# I.A. MEMORANDUM

SUBJECT: Planning & Public Works Committee Meeting Summary  
Thursday, May 9, 2013

- B. P.Z. 06-2013 Mercy Health System (Chesterfield Village, SE Quadrant):** A request for an ordinance amendment to modify the boundaries of the “UC” Urban Core District to incorporate two parcels zoned “C-8” Planned Commercial District into the “UC” Urban Core District totaling 43.35 acres located north of Chesterfield Parkway and east of Elbridge Payne Rd. (19S531791, 19S531801, 18S210028, 18S210149, 18S210073, 18S210062, 18S220148, 18S220171, 18S220061, 19S531922, and 18S210138).

- A. P.Z. 05-2013 Monarch Center (JLA Development, LLC):** A request for an ordinance amendment to a “PC” Planned Commercial District to add a 0.85 parcel of land currently zoned “M-3” Planned Industrial District to an existing “PC” Planned Commercial District and to modify development standards of the “PC” Planned Commercial District totaling a 10.94 acre area of land located north of Edison Avenue and east of Long Rd. (17U120188 and 17U120100).

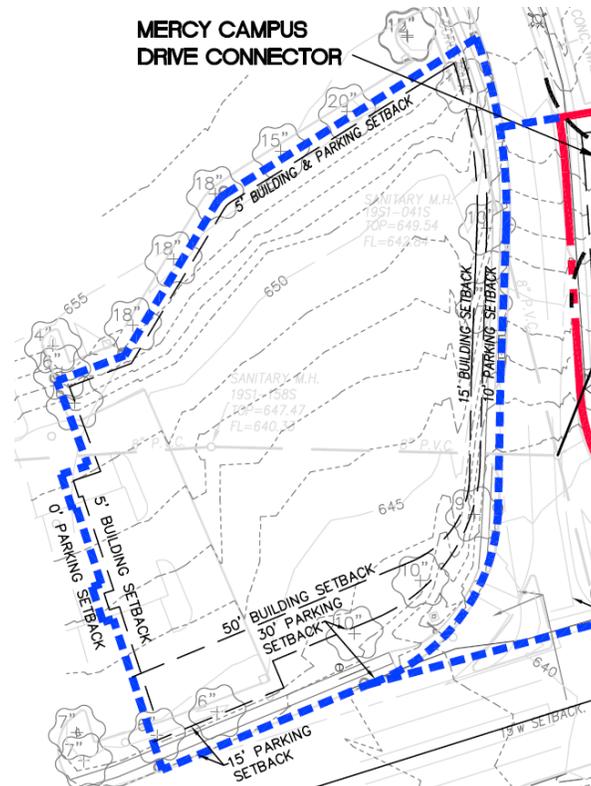
The proposed preliminary plan, depicted above, shows the removal of the existing “triangle” building with a new building being proposed in basically the same area. There are no development plans being proposed at this time for the new southwest parcel; however, the Petitioner wants to keep development options available for this parcel.

After discussions with the Planning Commission, the Petitioners are proposing the following parking setbacks for the southwest parcel (depicted above), 1281 Chesterfield Parkway East:

- 0' from the western boundary;
- 5' from the northern boundary;
- 10' feet from the eastern boundary; and
- 15-30' from the southern boundary.

Upon recommendation from the Planning Commission, the Petitioners have increased the building setback along Chesterfield Parkway from 30' to 50'. In exchange for this increased setback, they have reduced the building setback on the eastern boundary. This will give the Petitioners the same amount of developable area but will allow them to push the building further north and east providing an increased amount of area between the Brandywine development and a potential office building.

Councilmember Hurt expressed his concern with the access on the south side of the site.

***The City reserves the right to remove the proposed signaled access point on Chesterfield Parkway, or change it to a right turn in/right turn out, if the Petitioner acquires the property to the east.***

**The vote to add language to the Attachment A that allows the City to reserve the right to remove or change the proposed access point on Chesterfield Parkway in the event the Petitioners acquire the property to the east failed by a vote of 2 – 2. (Councilmembers Fults and Grier voted “no”).**

**Councilmember Grier then made a motion to forward P.Z. 06-2013 Mercy Health System (Chesterfield Village, SE Quadrant) to City Council with a recommendation to approve. The motion was seconded by Councilmember Hurt and passed by a voice vote of 4-0.**

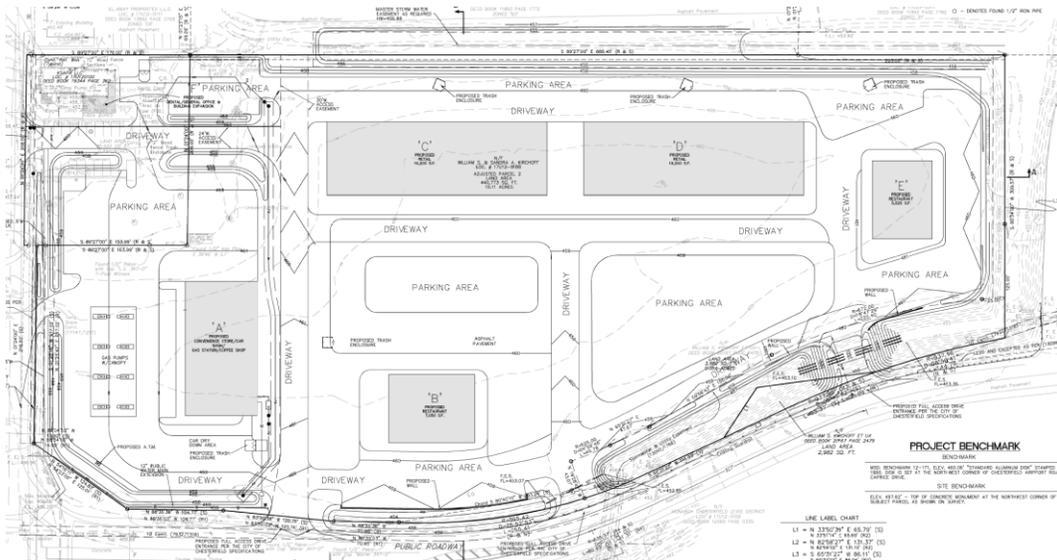
The proposed Preliminary Plan (*depicted above*) shows most of the major changes on the west side of the site. The other major change relates to Building E on the east side of the site, where the Petitioners are proposing a setback change from Edison Road from 125 feet to 65 feet. The requested setback change is to allow for more flexibility in the design to accommodate future users.

- A separate setback for the gas station canopy to be 50 feet from Long Road.
- An allowance to have an ATM located within the setbacks on the southwestern side of the gas station.
- Addition of the dental office building, which facilitates changes to the access.

The Petitioners are proposing a right-in only access into the service station. They are retaining the cross access requirements to the north and the storm water channel has been moved further to the east to prevent the internal drive from crossing it.

Planning Chair Watson stated that the major concerns expressed by the Planning Commission related to the 50-foot setback for the canopy and the location of the ATM.

Councilmember Grier asked whether Staff had any specific concerns with the access. Mr. Wyse stated that the 2001 agreement designates the access points along Edison Avenue. Staff's primary concern relates to: (1) the left-hand turn from Edison to go southbound on Long; and (2) the left-turn movement on Edison allowing access into the proposed service station.

Councilmember Hurt noted that the site has two access points within 330 feet on Edison Avenue and two access points on Long Road. He does not want any access points on Long Road and prefers only two access points on Edison Avenue with nothing closer than 380 feet. He added that he does not have a big concern over the proposed use.

- Regarding Building E, the proposed setback change from 120 feet to 65 feet from Edison was requested to make it consistent with the other setback requirements along Edison Avenue. If the Council wants to maintain the 120-foot setback, they are agreeable to it.

**Councilmember Grier made a motion to hold P.Z. 05-2013 Monarch Center (JLA Development, LLC): until the next Planning & Public Works Committee meeting to give Staff time to work with the Petitioner to address the concerns raised related to access and uses.** The motion was seconded by Councilmember Hurt.
